CRABBET PARK, OFFICE TO RESIDENTIAL

**ADDITIONAL INFORMATION TO
DISCHARGE PLANNING CONDITION 3**

5033004-RDG-XX-XX-T-C-300002

The purpose of this statement is to provide additional information to address the responses to discharge of Planning Condition 3 contained within further information request planning application DM/26/0846 dated 30th April 2026.

DRAWING No: 5033004-RDG-XX-XX-T-C-110500 Drainage Strategy.dwg

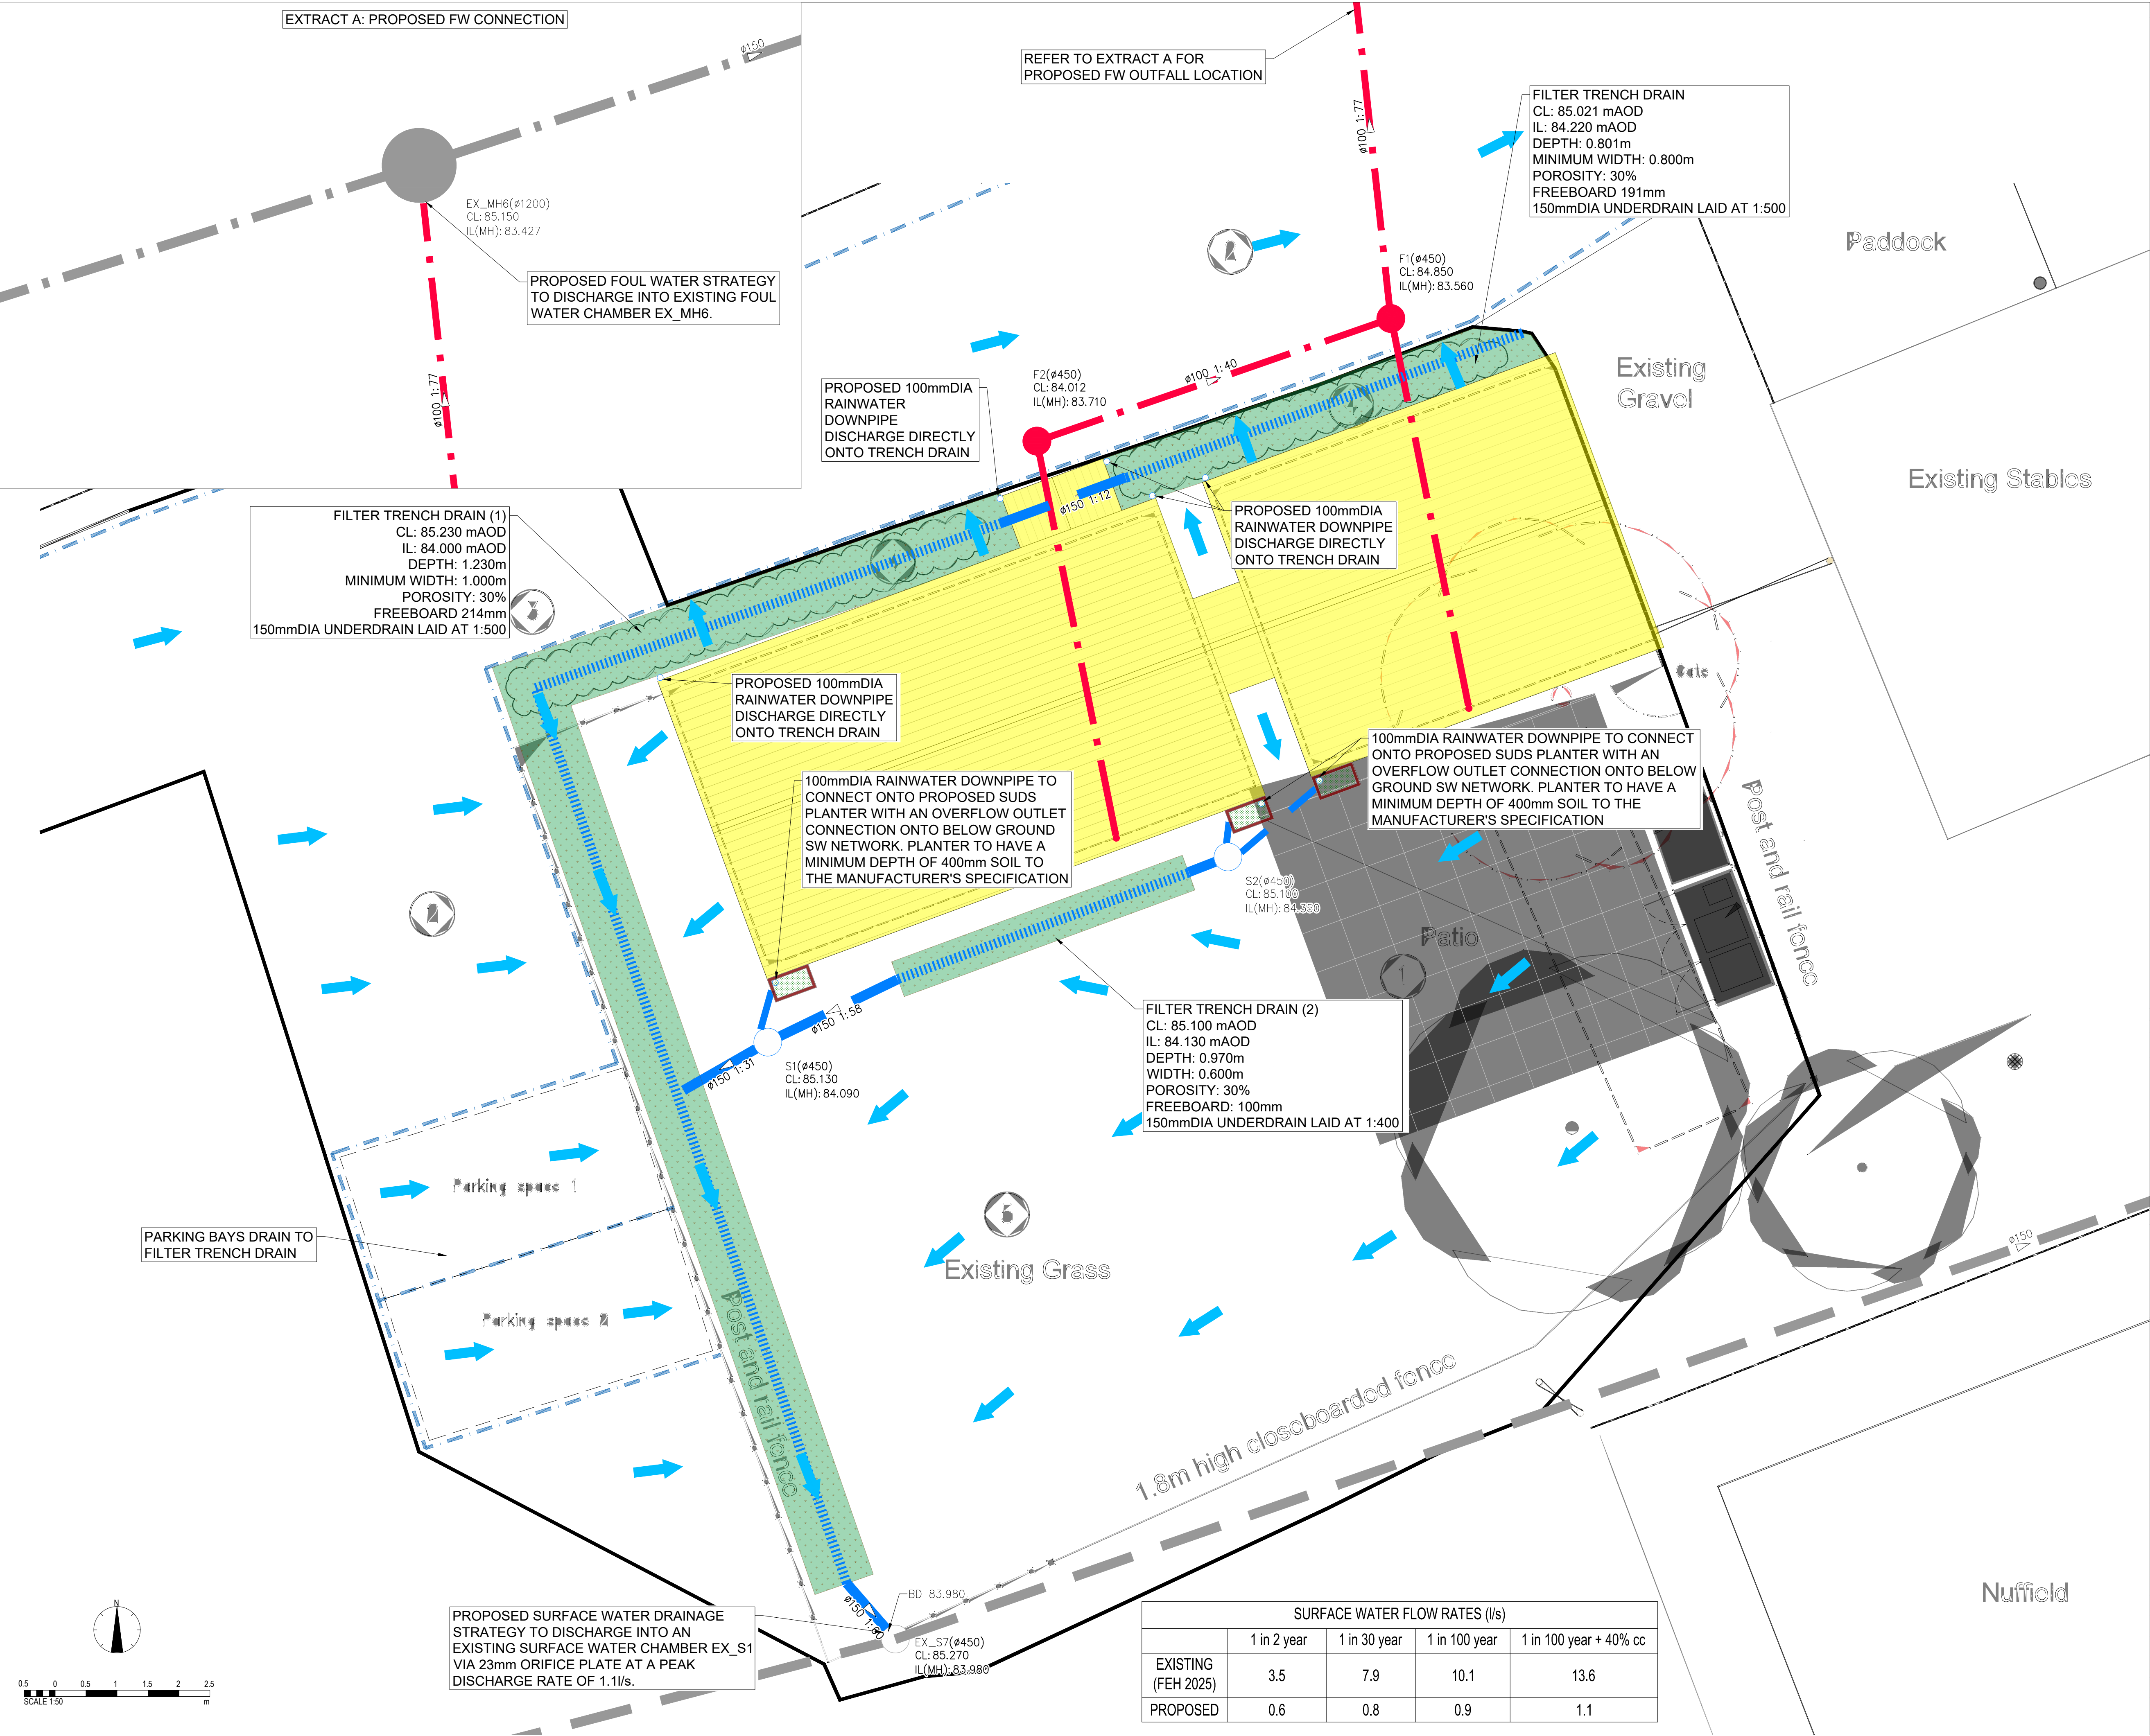
- 1. The discharge rate should be set as close as reasonably practicable to the greenfield runoff rate for the contributing site area being attenuated.*
- 2. Correspondence with the Water Authority is required to confirm the acceptability of both the surface water and foul water proposals. We would suggest that Thames Water are consulted on this application, we cannot access any information as to whether they have been at this stage.*
- 3. Design exceedance flow routes should be clearly shown on the proposed drainage layout.*
- 4. A management and maintenance plan should be provided.*
- 5. An allowance of 10% urban creep should be applied within the drainage calculations.*
- 6. Details should be provided to demonstrate that adequate water quality treatment is being achieved, in accordance with the CIRIA SuDS Manual.*

1: The discharge rate should be set as close as reasonably practicable to the greenfield runoff rate for the contributing site area being attenuated.

3: Design exceedance flow routes should be clearly shown on the proposed drainage layout.

In accordance with CIRIA SuDS Manual, the minimum orifice size for filtration-based drainage systems should be 20mm to reduce risk of blockages. The original proposal incorporated a 25mm orifice which we have reduced to 23mm with the surface water hydraulic model updated. This is the lowest possible rate of surface water discharge for the scheme that has no flooding for all rainfall events including the 1 in 100 year + 40%cc storm event. A breakdown of the proposed flow against existing can be summarised in Table 1 and the below ground drainage strategy drawing in **Appendix B**.

Exceedance flow paths have been added onto the proposed drainage strategy drawing – refer to the below ground drainage strategy in **Appendix B**.

P03	Minor amendments as per MSDC comments	05/08/2026	TW	EP
P02	Exceedance flow paths added onto drawing	14/05/2026	TW	PCh
P01	First issue	23/03/2026	TW	PCh
REV	DESCRIPTION	DATE	BY	CHKD
ORIGINATOR: www.ridge.co.uk
